WABUSH 3 OPEN PIT MINE PROJECT

Environmental Impact Statement Amendment

Iron Ore Company of Canada

March 2015

Figure 1 **Beverly Lake, Dumbell Lake, Leg Lake and Luce Lake Watershed Areas and Surface Water Flow Monitoring Stations**

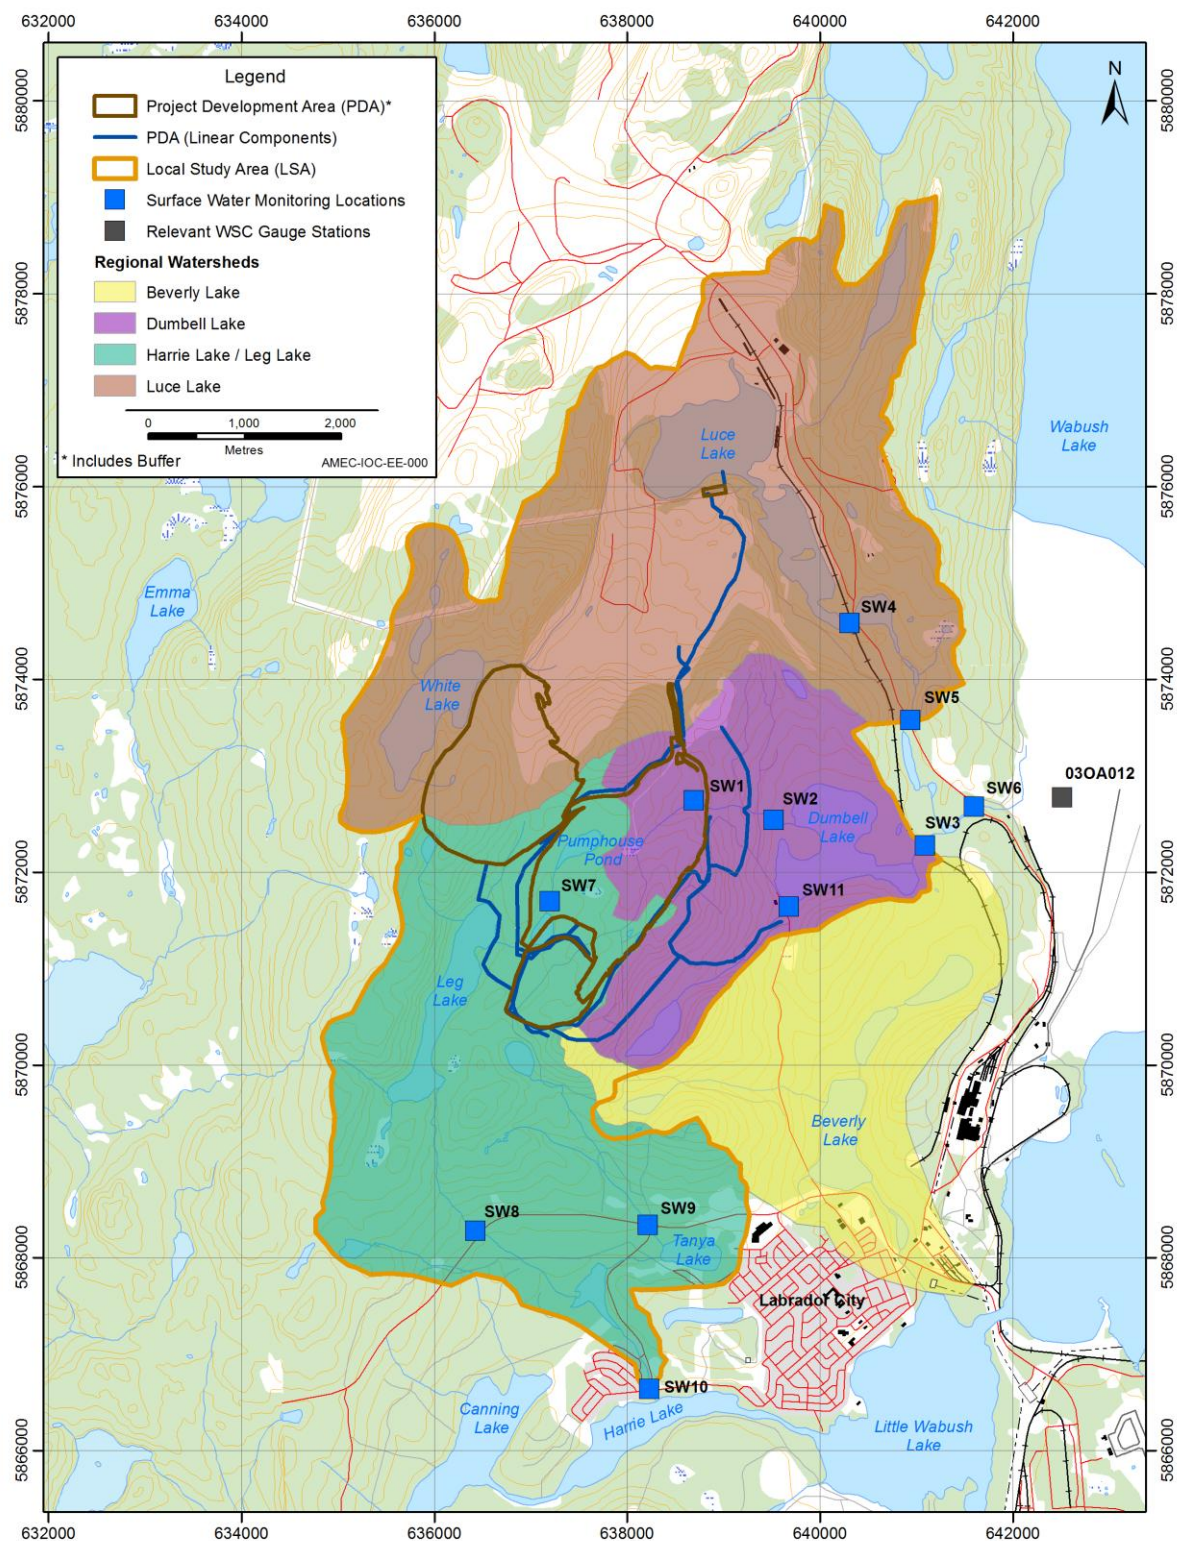
- 1) Incorporate surface flow to Dumbell Lake into the existing model in order to evaluate two additional scenarios, including:
 - a) Surface flow (and groundwater baseflow) component to the lake under steady-state conditions (pre-pit) and
 - b) The efficacy of the plan to discharge groundwater from pit-perimeter dewatering wells into the Dumbell and Leg Lakes water sheds

The results of these scenarios could then be compared in order to evaluate if the planned groundwater from dewatering wells pumped into the watershed will be adequate to address the anticipated loss of base flow to Dumbell Lake.

IOC has committed to a flow monitoring program at the inflow and outflow of Dumbell Lake (SW2 and SW3 on Figure 1). Flow monitoring will include installation of staff gauges and a pressure transducer / data logger at each of these flow gauging stations. The pressure transducer / data logger will measure and record water levels at an interval frequent enough to capture the range of water levels at these stations. The pressure transducers and staff gauges will be surveyed to a local temporary benchmark above the high water level to facilitate replacement of this equipment, to the same level, in the event of damage caused by ice, debris or vandalism.

Figure 1 Surface Water Quality Sampling Locations

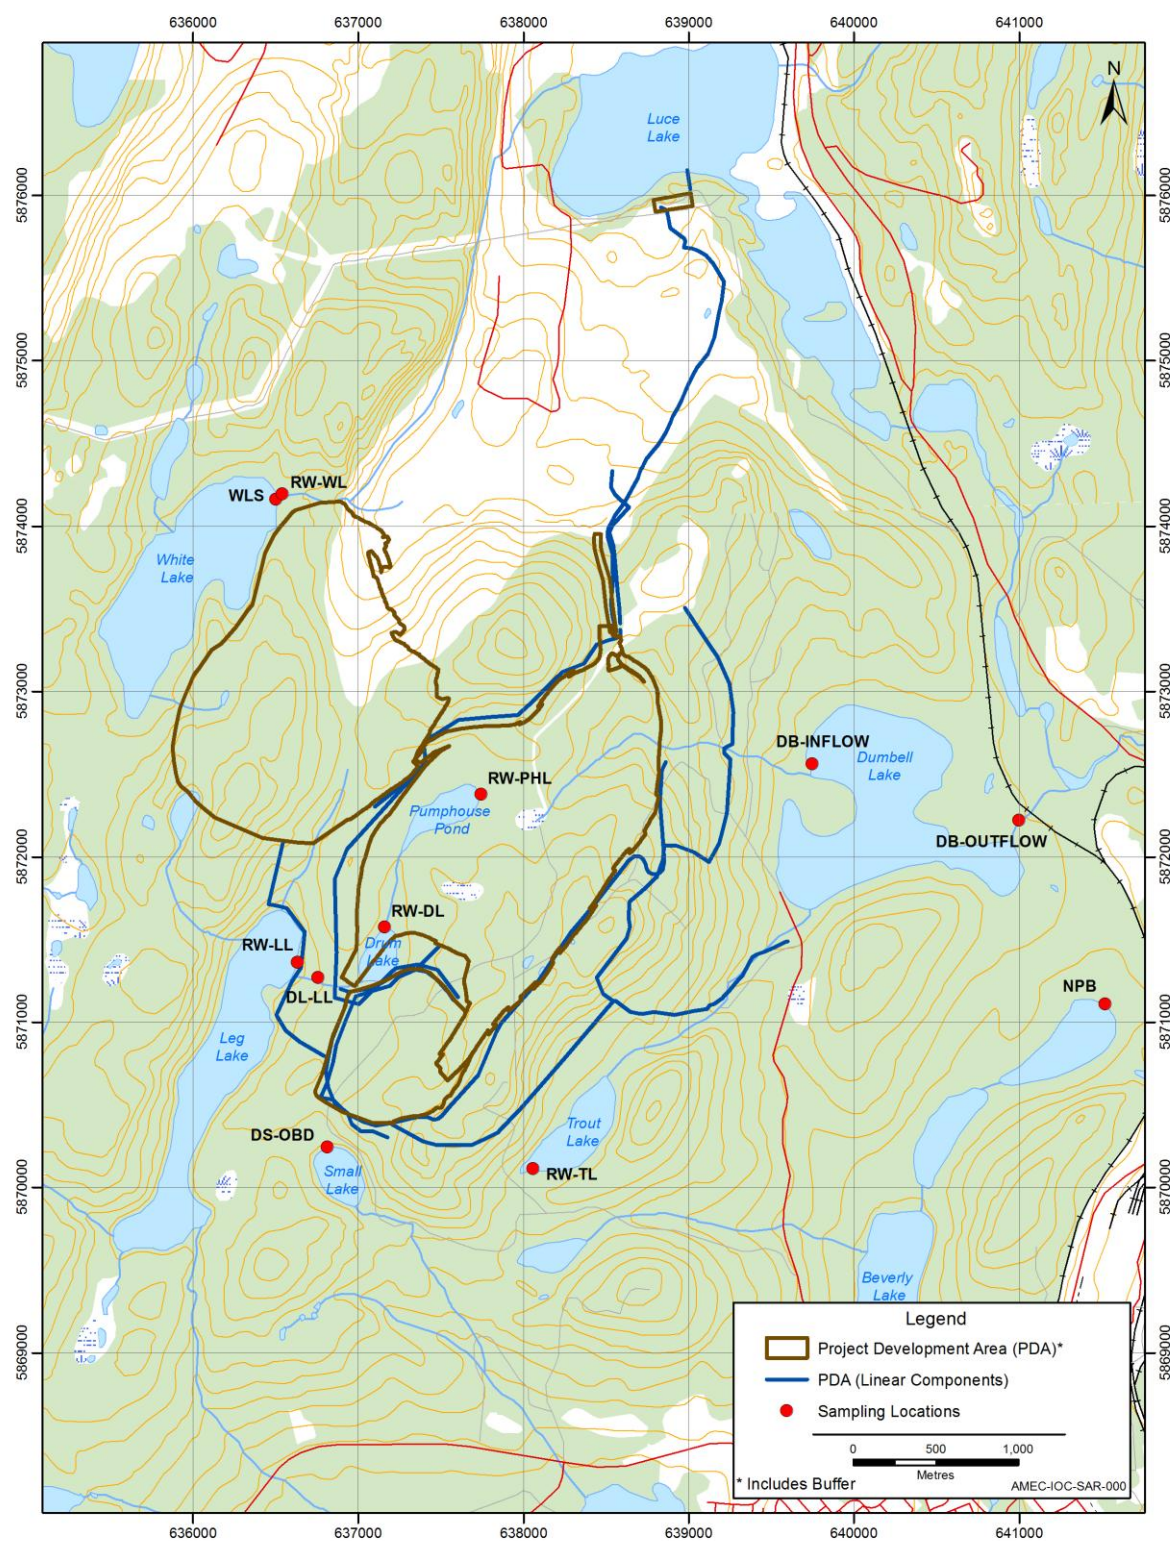
The EIS guidelines (4.18.3) requested that the proponent provide seasonal water quality field and lab analytical results and interpretation at several representative local stream and lake monitoring stations established at the Project site. There was limited water quality presented in the EIS for the project area and it did not satisfy the seasonality requirement. IOC is requested to provide data as indicated.

The surface water sample locations are shown on Figure 1. The surface water sampling program is summarized in Table 1 of Appendix 5. The analytical data were compared to the Health Canada Guidelines for Canadian Drinking Water Quality (GCDWQ) (Tables 2 to 5). For reference, the guideline of 1.0 NTU was used for turbidity to be consistent with the source water sampling completed by the Water Resources Management Division of the Department of Environment and Conservation. The analytical results are summarized as follows:

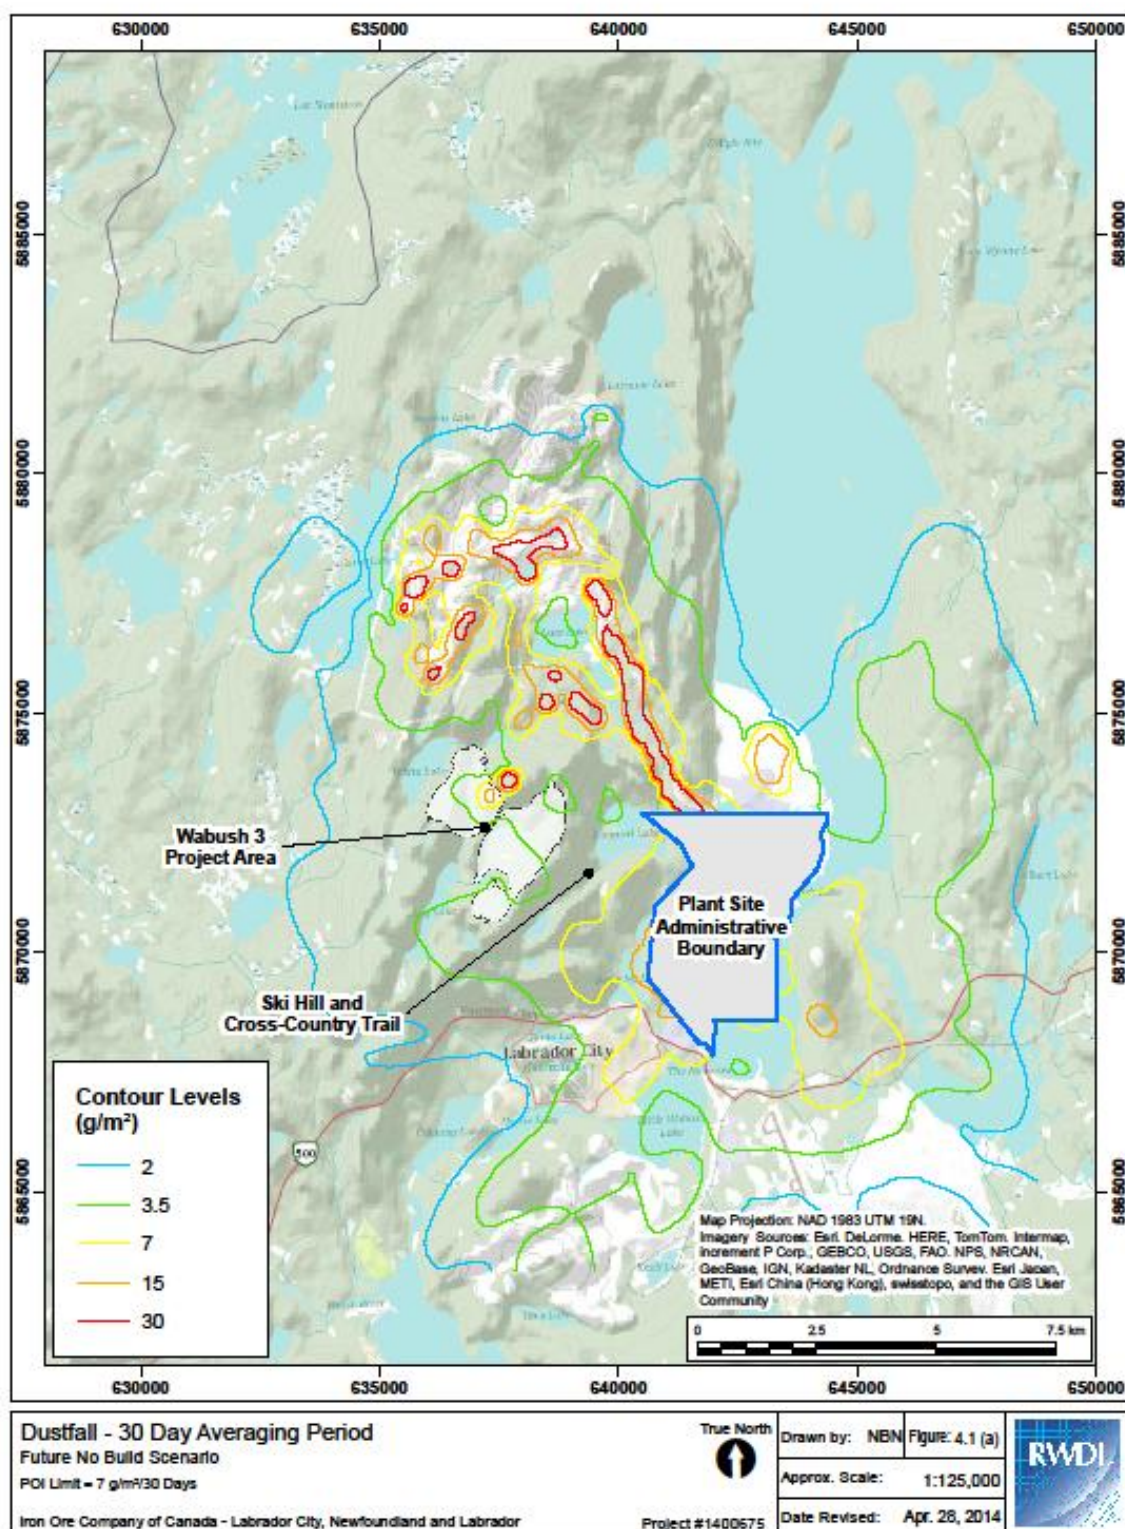
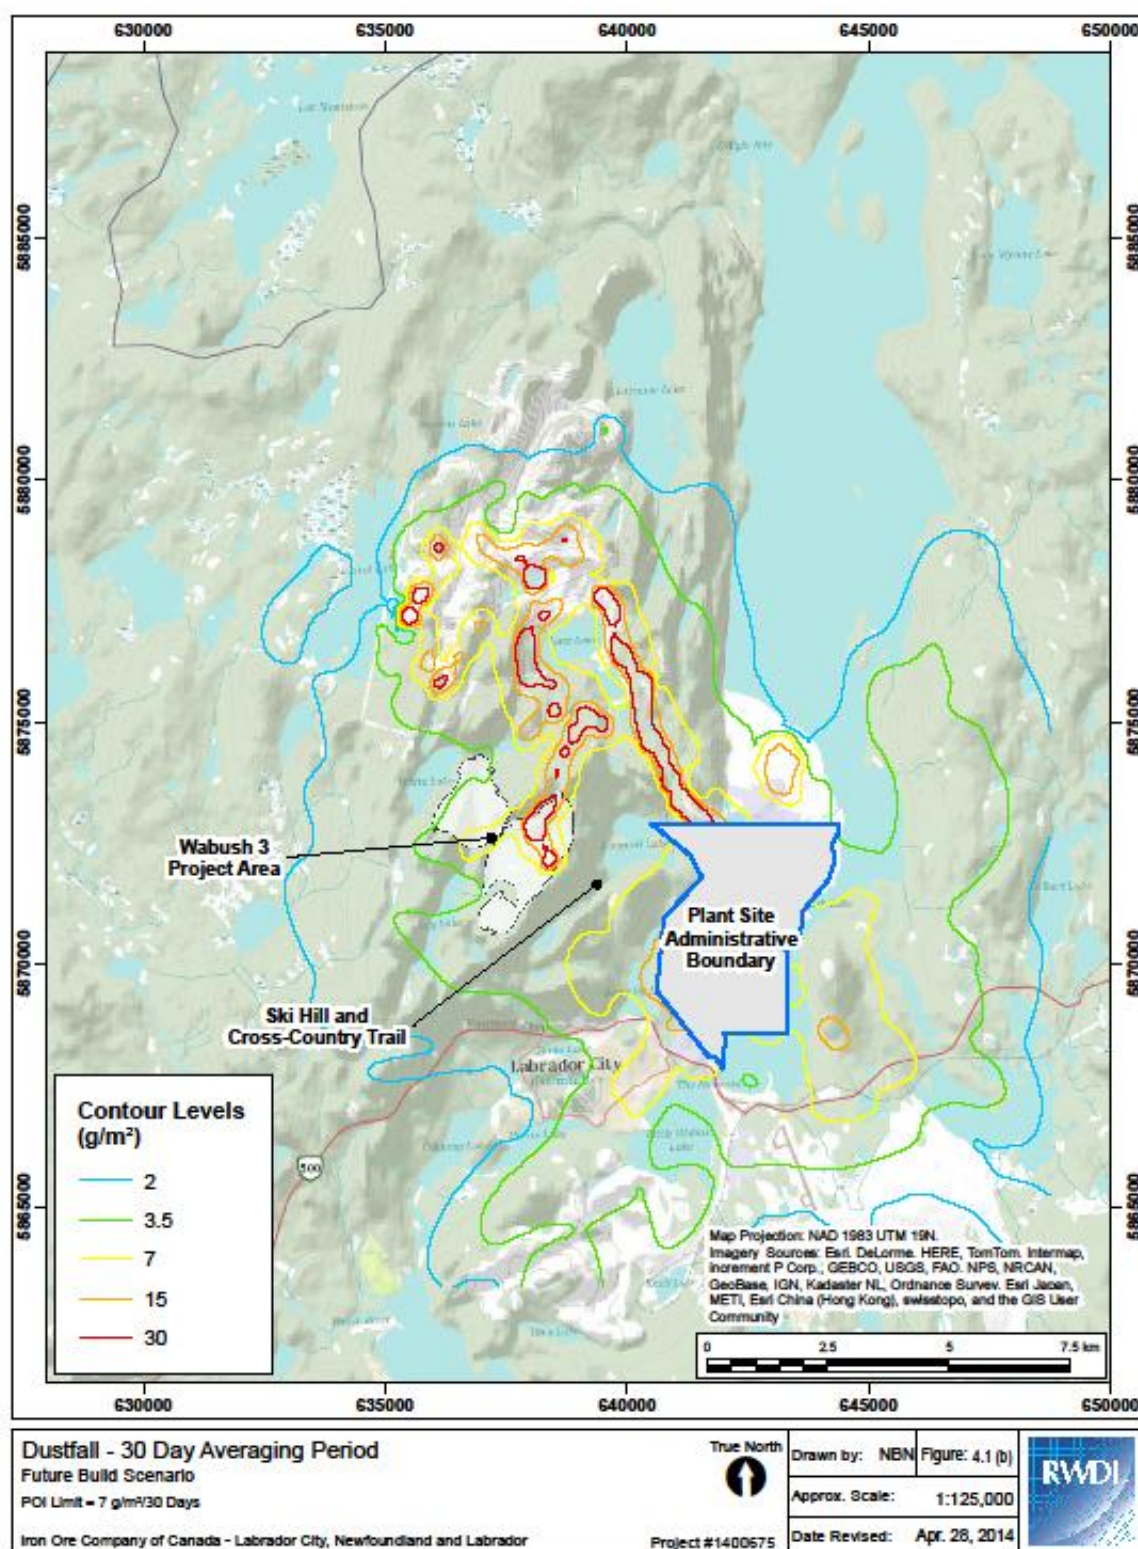
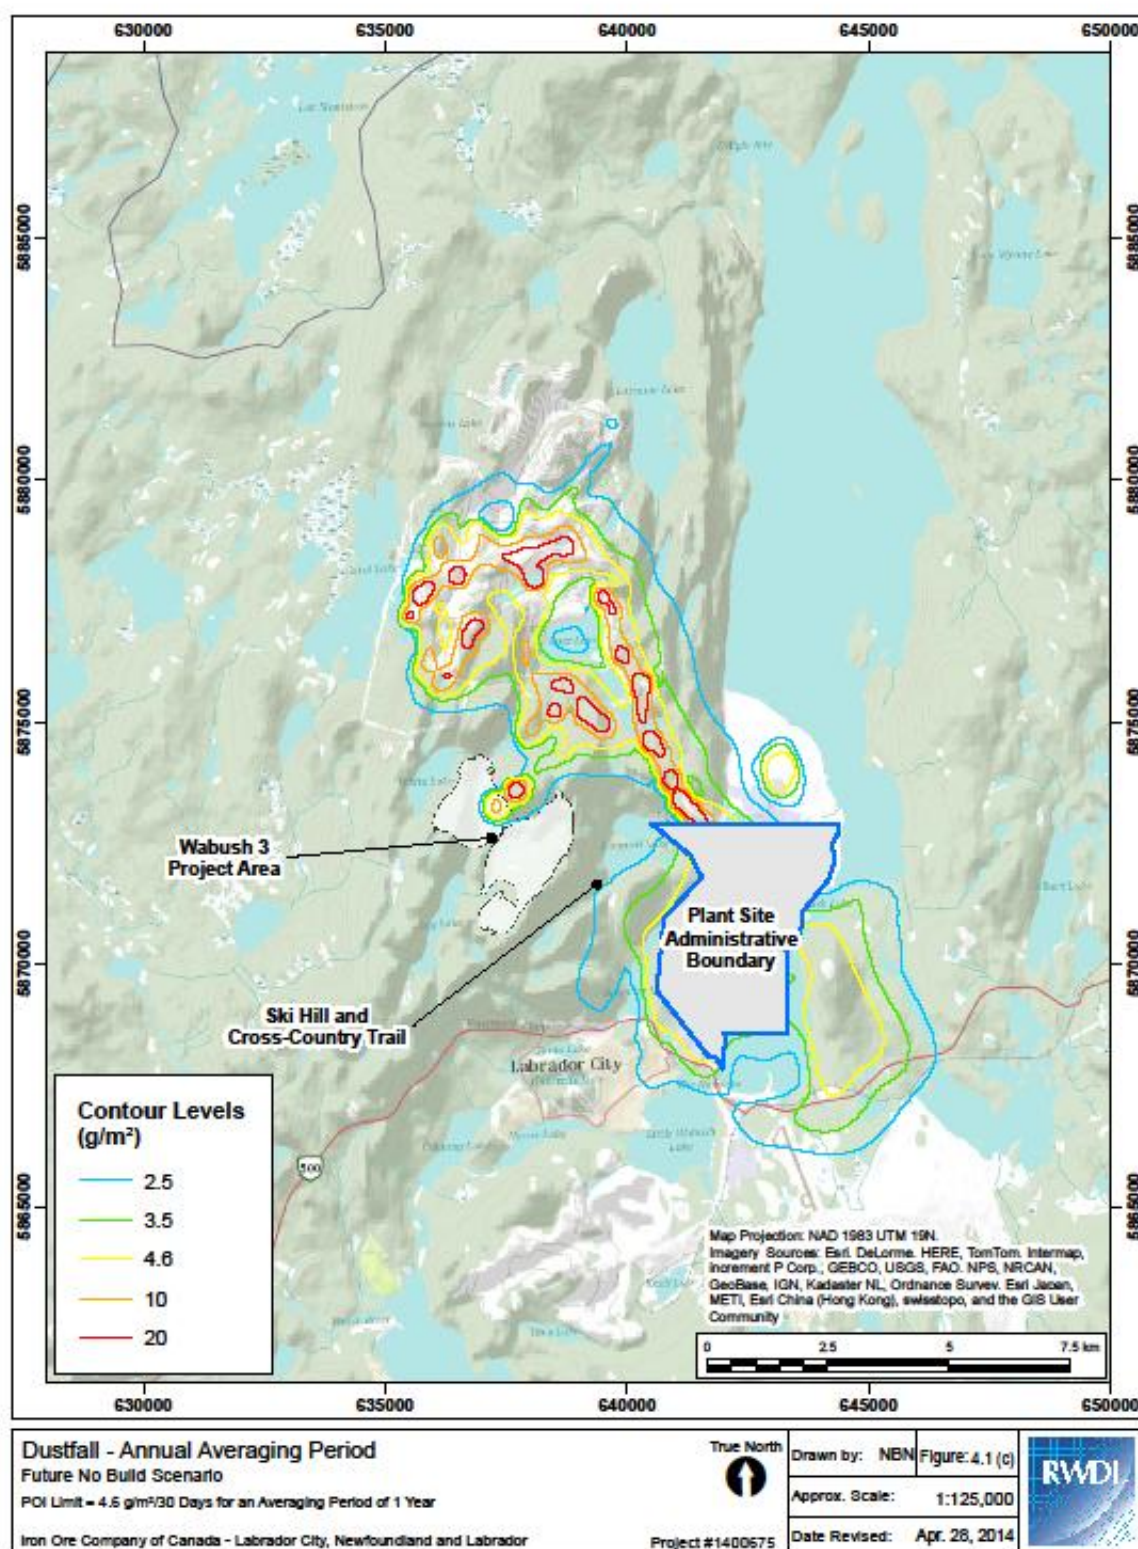
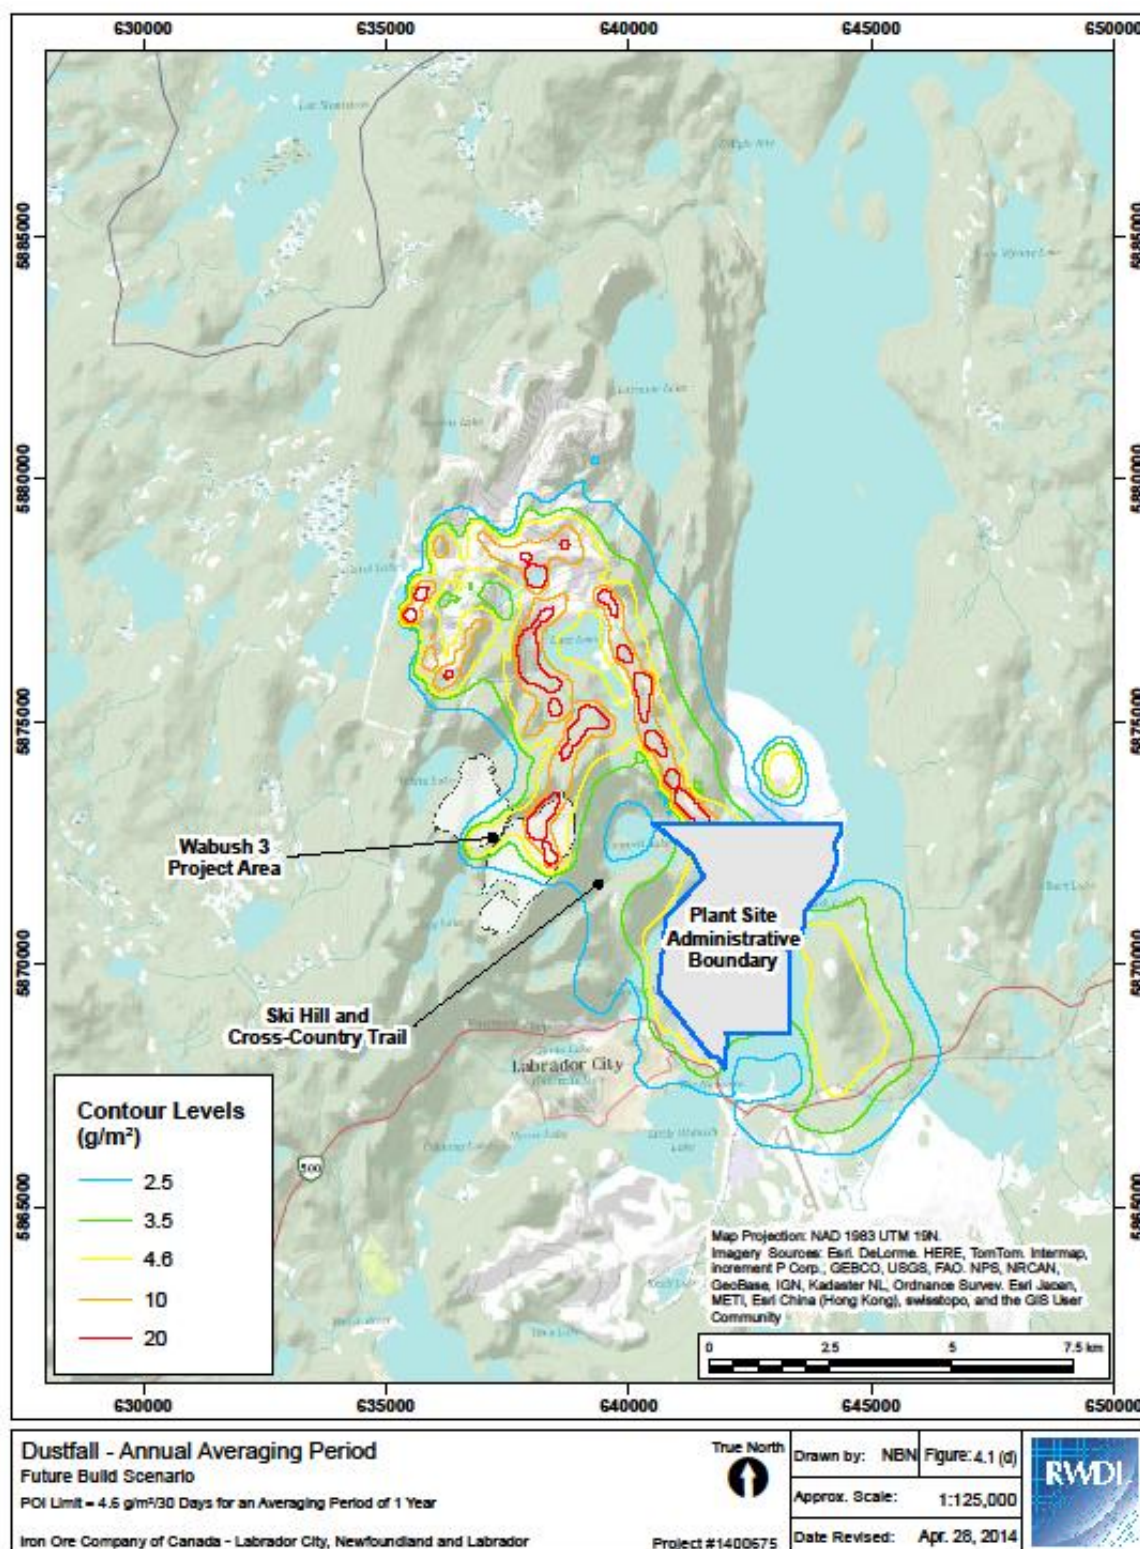
Various sections of the HHRA refer to dustfall isopleths that are to be on Figure 4.1. Figure 4.1 identifies the receptor locations but does not show the dustfall isopleths. Dustfall isopleths are presented in Chapter 10 of the EIS, and should be either referenced or recreated in the HHRA for ease of review. Please ensure that all figures contain the information described in the text of the report.

Dustfall isopleths were not included in Figure 4.1 of Appendix 25 and this was an oversight. The figures in EIS Chapter 10 considered TSP, PM₁₀ and PM_{2.5}, but did not consider dustfall. Four figures showing Dustfall (30 day and Annual averaging periods) for the Future No Build and Future Build scenarios have been prepared by RWDI and are provided below.
